Product Change Notification

Change Notification #: 107746- 00
Change Title: Boxed Intel® Core™2 Duo Desktop Processor E4400, PCN 107746-00, Product Design, L-2 to M-0 Stepping Conversion
Date of Publication: Jul 19, 2007

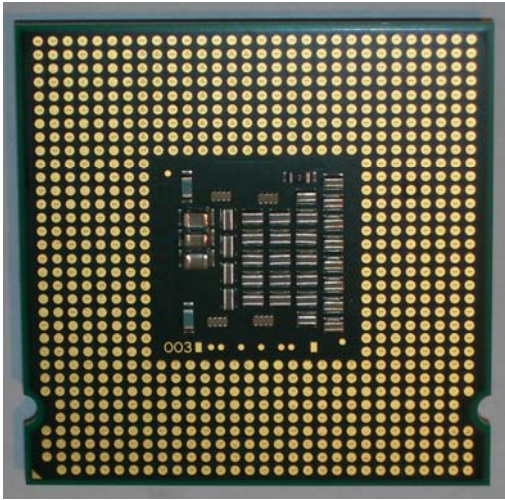
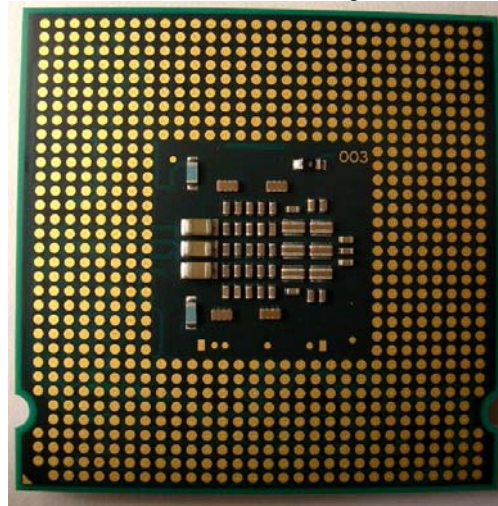
The boxed Intel® Core™2 Duo desktop processor E4400 will undergo the following changes for the L-2 to M-0 stepping conversion:

- New S-Spec and Material Master Number for the converting product
- CPUID will change from 6F2 to 6FD
- The Electrical and Mechanical Specifications remain within the current specifications. Intel anticipates no changes to customer platforms designed to previous Intel guidelines
- Thermal specification has changed:
 - Extended HALT power specification will reduce from 12 Watts to 8 Watts
 - Maximum allowed Case Temperature will increase from 61.4°C to 73.2°C
 - Tcontrol offset will remain the same relative to 0 with the increase in maximum allowed Case Temperature, which will help reduce acoustics
- Minor visible difference between the L-2 and M-0 packages (see below for a visual comparison).
 - While the packages are visually different, the M-0 package is pin-compatible with the L-2 package and Intel anticipates no changes to customer platforms designed to Intel guidelines.
